SUBJECT: TECHNICAL SPECIFICATION CHANGES INVOLVING THERMAL-HYDRAULIC STABILITY, SECTION 3.5/4.5-M (TAC 73435) (TS 272) - BROWNS FERRY NUCLEAR PLANT, UNIT 2

TENNESSEE VALLEY AUTHORITY
DOCKET NO. 50-260
BROWNS FERRY NUCLEAR PLANT, UNIT 2
AMENDMENT TO FACILITY OPERATING LICENSE

Amendment No. 174
License No. DPR-52

SAFETY EVALUATION BY THE OFFICE OF NUCLEAR REACTOR REGULATION

Figure 3.5.M-1
BFN Power/Flow Stability Regions

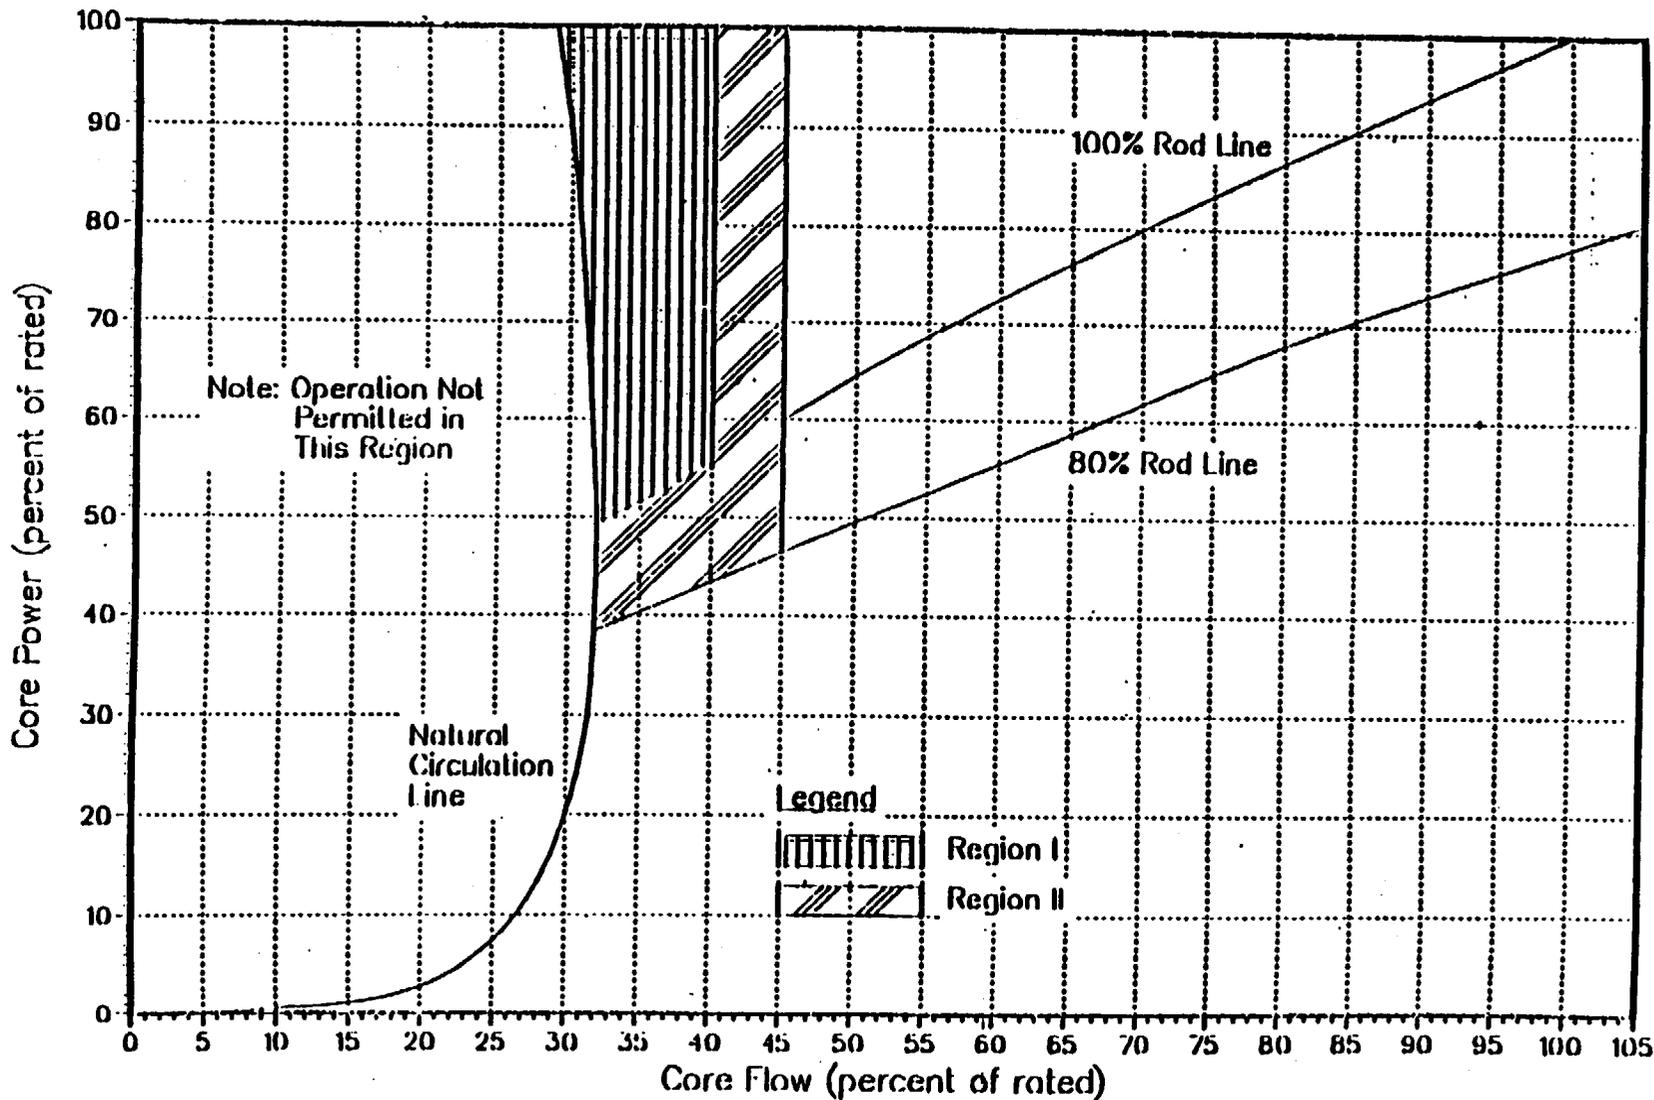
1. The reactor shall not be operated at a thermal power and core flow inside of Regions I and II of Figure 3.5.M-1.
2. If Region I of Figure 3.5.M-1 is entered, immediately initiate a manual scram.
3. If Region II of Figure 3.5.M-1 is entered:

The minimum margin to the onset of thermal-hydraulic instability occurs in Region I of Figure 3.5.M-1. A manually initiated scram upon entry into this region is sufficient to preclude core oscillations which could challenge the MCPR safety limit.

Because the probability of thermal-hydraulic oscillations is lower and the margin to the MCPR safety limit is greater in Region II than in Region I of figure 3.5.M-1, an immediate scram upon entry into the region is not necessary. However, in order to minimize the probability of core instability following entry into Region II, the operator will take immediate action to exit the region. Although formal surveillances are not performed while exiting Region II (delaying exit for surveillances is undesirable), an immediate manual scram will be initiated if evidence of thermal-hydraulic instability is observed.

The proposed BFN2 TS conservatively implements these region designations and associated operational requirements by adding a new specification, TS 3/4.5.M, Core Thermal-Hydraulic Stability, and power-flow map, Figure 3.5.M-1. The regions designated in the figure are the same as in IRSA except that regions B and C are combined into a single Region II (and Region A is designated Region I). The IRSA operating restrictions of Region B are conservatively applied throughout Region II. There is no allowed operation such as is permitted by IRSA for, e.g., startup in Region C. TS 3.5.M.1, 2 and 3 specify that operation is not permitted in Regions I and II, and upon inadvertent entry, scram is required if in Region I, and immediate initiation of action to depart by control rod insertion or flow increase is required for Region II. While exiting Region II, scram is required if there are indications of instability as evidenced by APRM oscillations above 10 percent peak-to-peak of rated power or LPRM oscillations above 30 percent, and LPRM upscale or downscale alarms require immediate checks of APRM and LPRM readings. These requirements all meet or exceed the IRSA specifications and are acceptable TS for meeting the bulletin requests for implementing the interim recommendations. TS 4.5.M provides surveillance requirements for determining that operation is outside of Regions I and II when operating in the vicinity of these regions. They too are acceptable. The new Bases 3.5.M provides a reasonable discussion of the background, regions, operations and requirements for these specifications and is also acceptable.
